UNITED STATES PATENT AND TRADEMARK OFFICE

Office Action Summary

10/697,843

KRAFT ET AL.

coupling element for claim 22

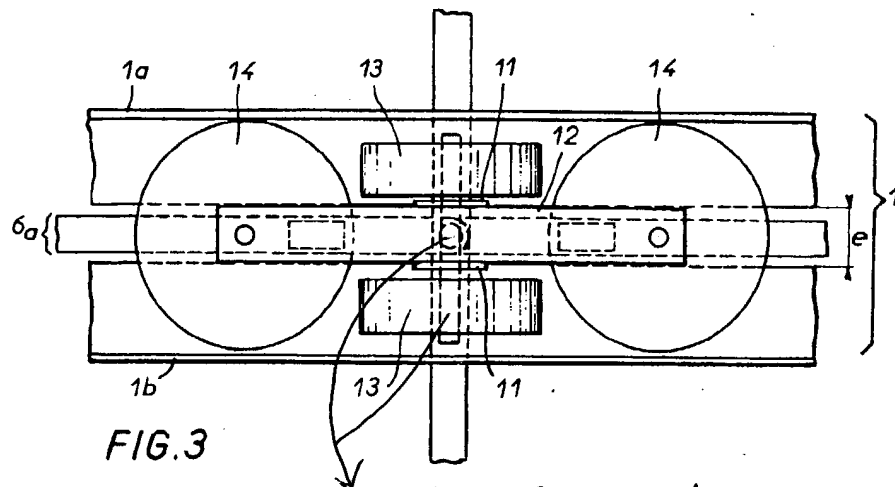
4. Claims 1-3, 5-8, 13, 17-26, 30 and 31 are rejected under 35 U.S.C. 102(b) as being anticipated by Hesnault (US 4,138,966) (Please see a more detail Figure 3 of Hesnault attached with the Office Action for further explanation for claim 22).

For claim 21, Hesnault further discloses the supporting structure comprises a first (1a) and a second rail (1b) in parallel with each other, and wherein the traveler comprises at least a first (13) and a second traveler part (13), with the first traveler part being moveably arranged on the first rail and the second traveler part being moveably arranged on the second rail (see Figure 3).

For claim 22, Hesnault further discloses the coupling element for connecting the first and parts (see attached Figure 3).
